## PRODUCT CHANGE NOTIFICATION

LSR Part Number	Old Rev	New Rev	Description
450-0075	2	3	RF Module, ProFLEX01-R2 F Antenna Module
450-0076	2	3	RF Module, ProFLEX01-R2 U.FL
450-0004	2	3	Dev Kit, ProFLEX01-R2 F Antenna
450-0005	2	3	Dev Kit, ProFLEX01-R2 U.FL Connector
450-0101	3	4	MGE, ProFLEX01-R2, Packaged Assy
450-0102	3	4	MGU, ProFLEX01-R2, Packaged Assy

Method of Identifying the Changed Product:

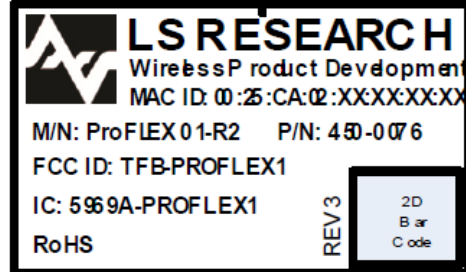
Updated the firmware in the ProFLEX01-R2 modules to:

- The mechanism to disable the CCA was not working due to one of the changes in the 3.2 release.
- OTA security on repeated messages was not working due to one of the changes in the 3.2 release.

CCA setting (sent on a message by message basis) can fail to be applied after module is put to sleep
